Access Compliance Report Public Rights-of-Way (Pedestrian Signals)

Main Street: **OLD_RANCH_RD** Cross Street: **FAIRMONT_BLV** Location: **NW**

ADA ID: **SGAT210921145540** Signal Type: **One Push Button-Non APS** Overall Compliance: **No** Severity Scores: **BTN 1: 35** **BTN 2: N/A** **No BTN: N/A**

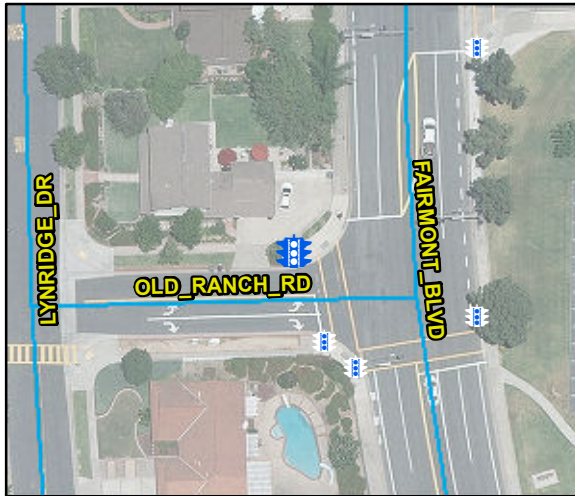
OC Std/PROW: **MUTCD 4e.08, R404.2**

Possible Solutions: Replace Signal Push Button With APS Button. Remove & Relocate Sign.
